From: [Planning](#)
To: [Cynthia Vigeland](#)
Cc: [Jason Goff](#); [Eric Lardy](#)
Subject: FW: PC Hearing Carlsbad Village Mixed Use SDP2023-0014
Date: Wednesday, July 17, 2024 12:58:47 PM
Attachments: [Planning Commission Letter SDP-2023-0014.pdf](#)

RE: COMMENTS AND CLARIFICATION REQUEST FOR SEVERAL STAFF FINDINGS IN THEIR REPORT

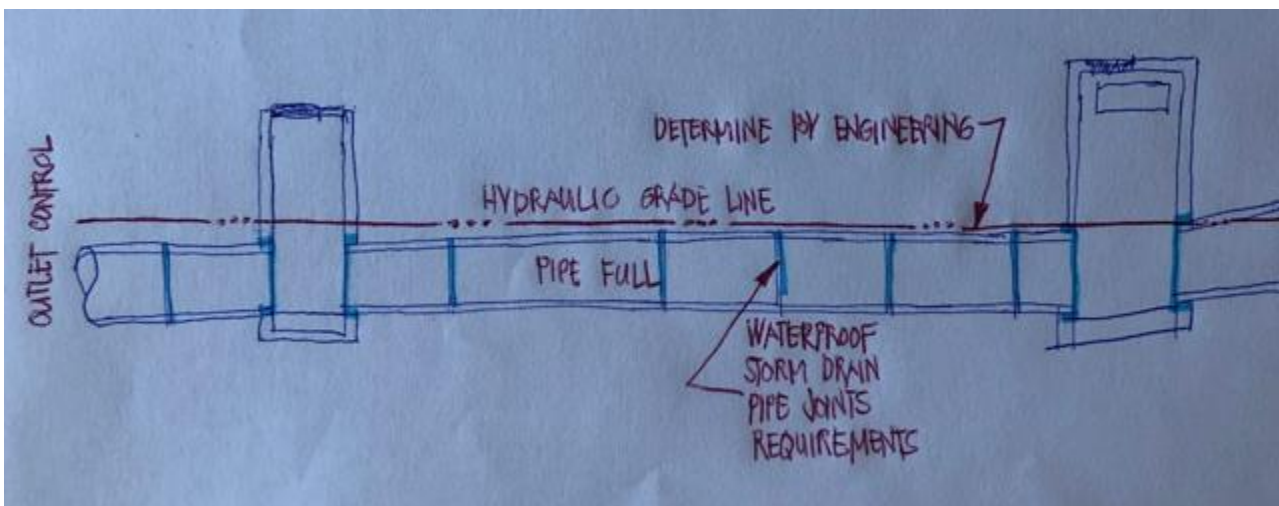
There is a approximately 27 or 22 as both numbers are in the Staff file and Neg Dec, states, “negotiations are ongoing” that is another item needs a finite number and should be identified in the site plan. I’m unsure if a vote by the Planning Commission is possible with exact information.

The Neg Dec needs to be revised to match the exact number for Public Records.

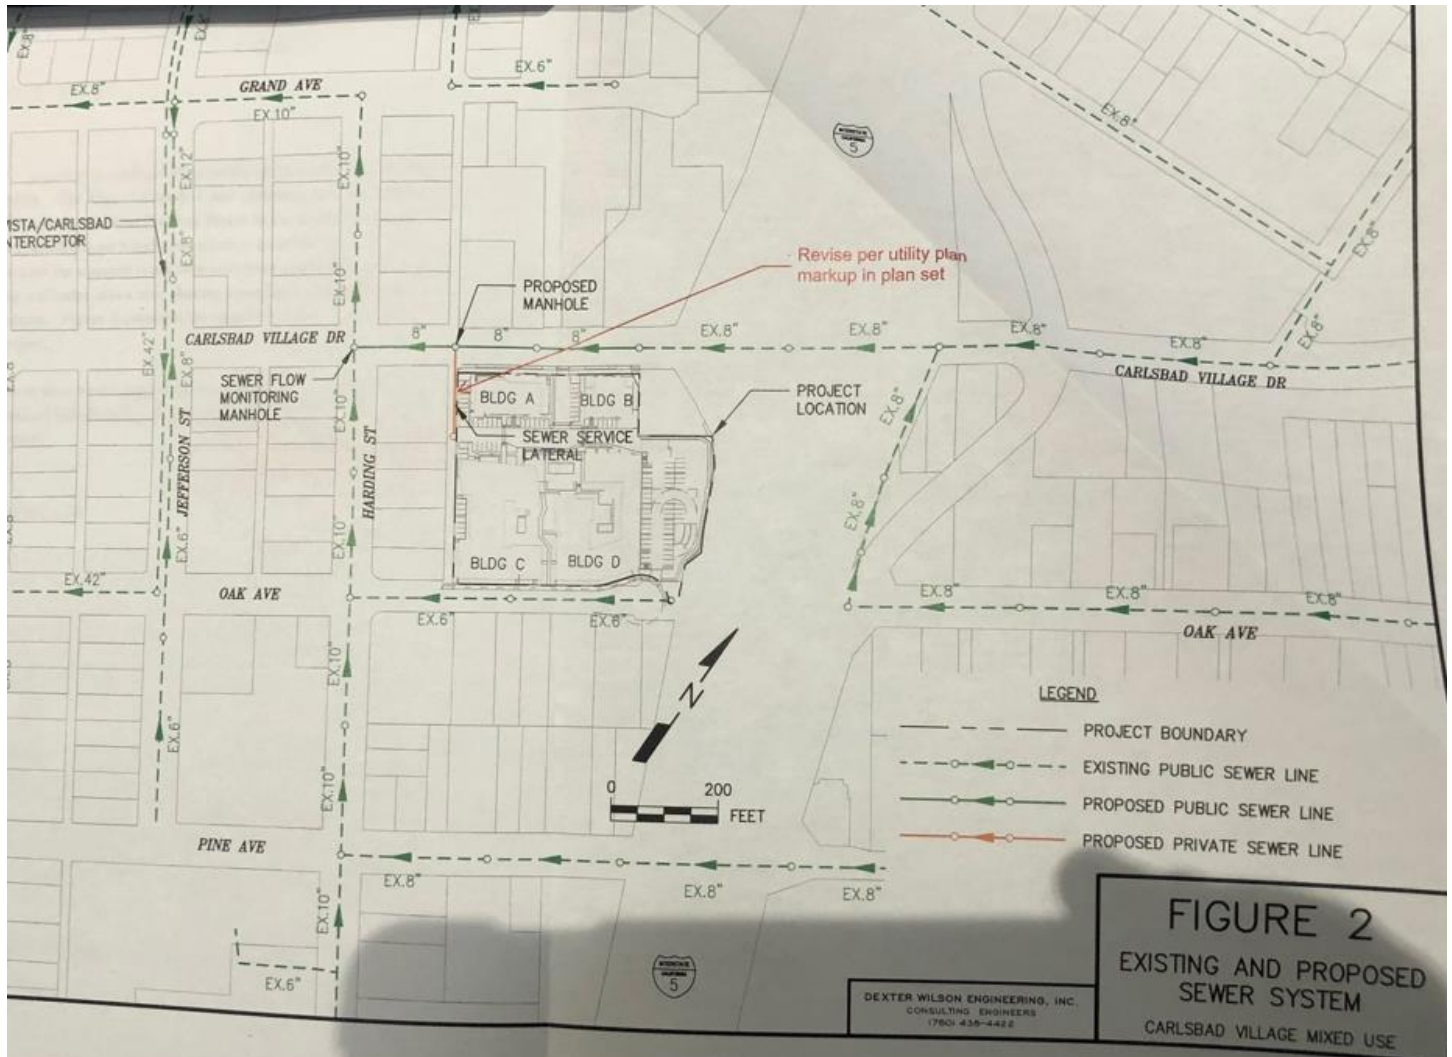
There did not appear to be an approval from the Encina Wastewater Department on increase in sewage gallon measurements. There were several sheets with redline markups and proposed increases in flow. I did not review those calculations for accuracy, however; the general volume appeared low since there are 12 individual rental spaces with bathrooms and vacant restaurant. The increased difference from $218 - 12 = 206$ or 17X the effluent flow and I didn't see that corresponding in the Engineers calcs. Additionally, I do note the a new 8" PVC pipe and 10" PVC pipe in Harding street to increase capacity to allow sewage to be contained in pipe at confluence in manhole requiring reto-work. Essentially the 10" pipe is needed for the hydraulic grade line to hold sewage back until the existing 8" outlet control is flowing low enough to siphon the sewage out of the 10" pipe.

May I suggest the City Staff Condition additional fees for upgrading sewer trunk pipe in future based on analysis of future density. Currently the Development Fees portion for Sewer Upgrades will not cover this cost entirely. Since current depth of sewer is shallow a larger pipe is not a feasible solution, however; a parallel pipe the same size may allow interception of existing laterals to a modified Manhole for 2 conduits in the future. This would avoid impacts to existing dry and wet utilities.
